ADMINISTRATIVE APPLICATION CHECKLIST

Water Injection Pressure Increase Request Injection Order WFX-835 Central Vacuum Unit #456 API# 30-025-38638 UL F Sec 36 T17S R34E 1360' FNL 1980' FWL Lea County

Central Vacuum Unit #457 API# 30-025-38639 UL G Sec 36 T17S R34E 1593" FNL 1912" FEL Lea County

RE: Application pMAM1508959736; IPI for Central Vacuum Unit No. 456 (30-025-38638) and Central Vacuum Unit No. 457 (30-025-38639)

CENTRAL VACUUM UNIT # 457

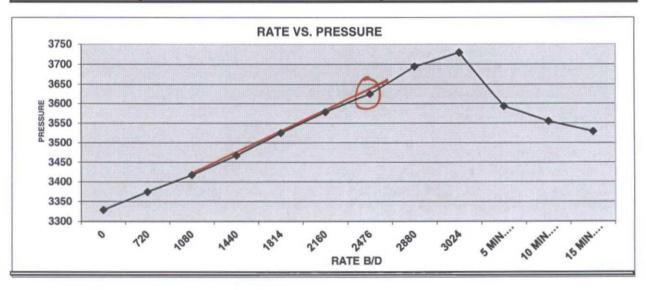
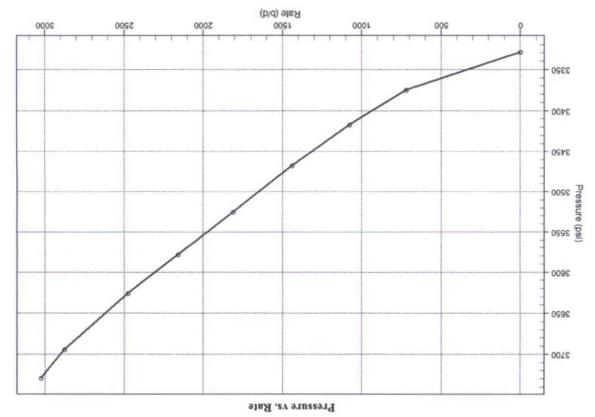
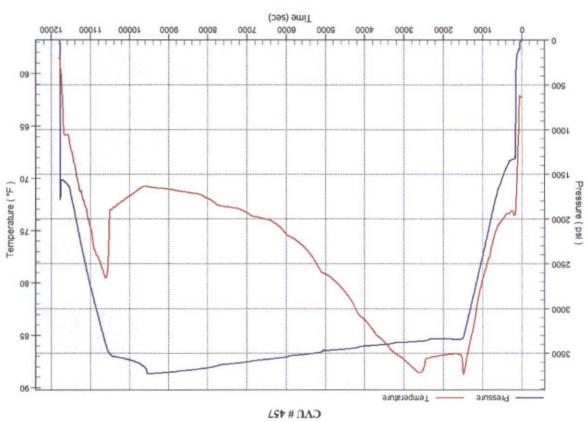
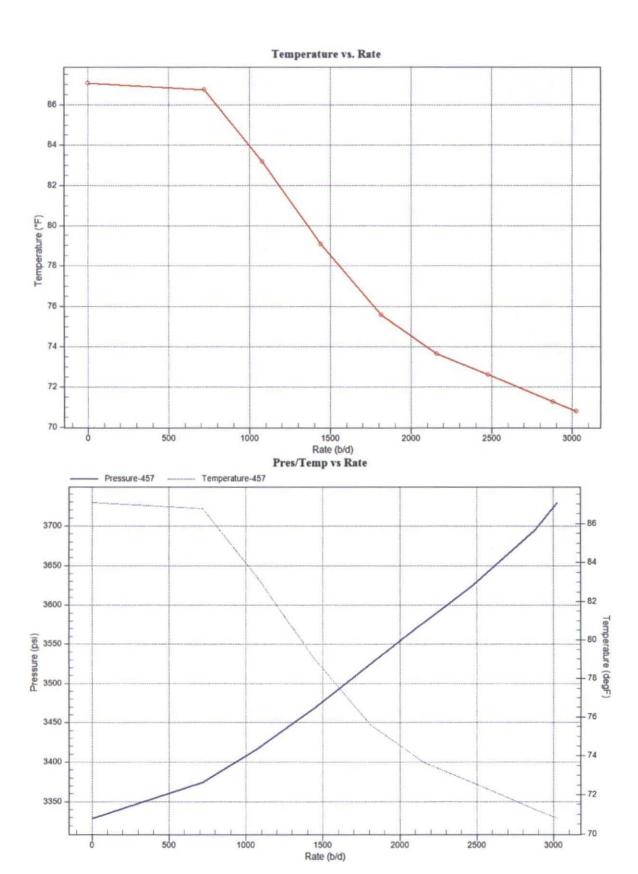
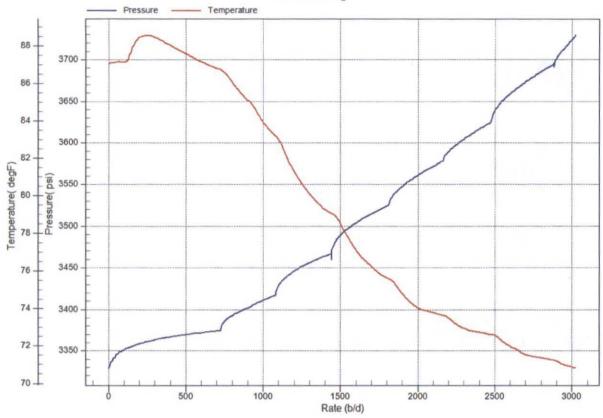
1. The SRTs only provide bottom hole pressure measurements, but no corresponding surface readings were included. As a result, I will be required either to derive calculated surface pressures or use a non-D'Arcy inject rate plot of the supplied data to assess the "no frac was observed" statement provided by the vendor. Also, the

orders are issued based on a maximum <u>surface</u> injection pressure. This is critical since both wells have been in violation (what is categorized as a Level I violation under the SWDA) for exceeding their maximum surface pressure. The bottom hole pressures being suggested for approval are close to the formation parting pressures for other wells within the Central Vacuum Unit. This may be addressed by either providing this data, or your application will have to wait until. I have time to do calculations.

- 2. No shut-in time was provided when was the well suspended from operation prior to initiating the?
- 3. Density of fluid used for the SRT (fresh water, produced water?)
- 4. Current well diagram are the respective ones in the OCD well files current?

- 1. The SRTs only provide bottom hole pressure measurements, but no corresponding surface readings were included. As a result, I will be required either to derive calculated surface pressures or use a non-D'Arcy inject rate plot of the supplied data to assess the "no frac was observed" statement provided by the vendor. Also, the orders are issued based on a maximum <u>surface</u> injection pressure. This is critical since both wells have been in violation (what is categorized as a Level I violation under the SWDA) for exceeding their maximum surface pressure. The bottom hole pressures being suggested for approval are close to the formation parting pressures for other wells within the Central Vacuum Unit. This may be addressed by either providing this data, or your application will have to wait until I have time to do calculations...... The parting formation pressure for other wells within CVU is about 3800 psi bottom hole and 2100 psi surface, see attachment for recent SRTs for CVU 107 and CVU 108

- 2. No shut-in time was provided when was the well suspended from operation prior to initiating the ?......CVU 456 was shut in 2/16/2015 and CVU 457 was shut in on 3/15/2015, both tests were done on 3/17/2015

- 3. Density of fluid used for the SRT (fresh water, produced water?).....Produced water was utilized, density is 1.08 gram/cm3
- 4. Current well diagram are the respective ones in the OCD well files current?......Also see attachments for current WBD
